RE: TEDS Exception from Minimum Storage for Drive-up Banking Facilities for Branch Banks

DESIGN EXCEPTION #DE20-02

RE: Exception from Minimum Vehicle storage for Drive-up Banking Facility

SUBJECT: TEDS Exception for 1st National Bank of the Rockies at Redlands
Marketplace

PROPOSED SITE PLAN

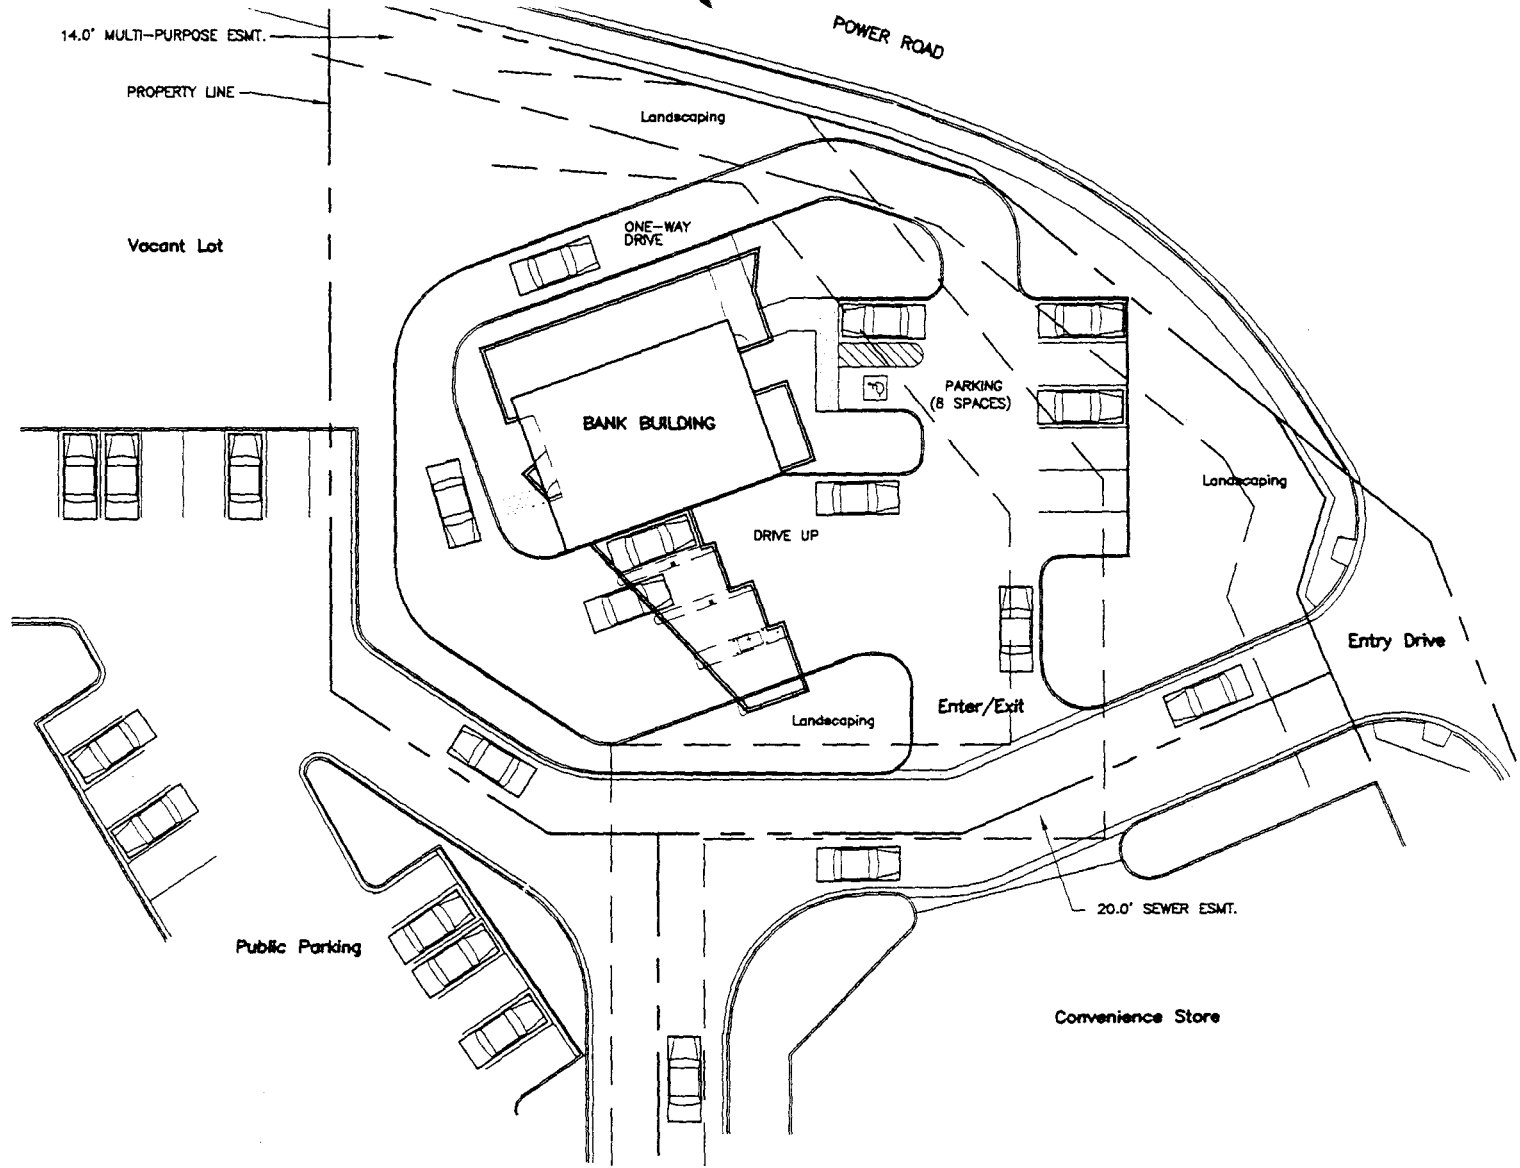
This is a borderline TEDS exception, and so I recommend approval. However, the site should provide sidewalk along it's frontage, from Power Rd. to it's west property line (as should have been provided in the original Albertson's Complex planning review).

This site has borderline drive through storage, if the entire access length through this parcel is considered. Should that available storage be exceeded, though the impact to the Albertson's complex main access route may be compromised, there is little chance backups could effect Power Rd. flow. So, though this site's parking access / egress may be periodically obstructed by potential drive-through backups, the only derived detriment would be to this site's own circulation.
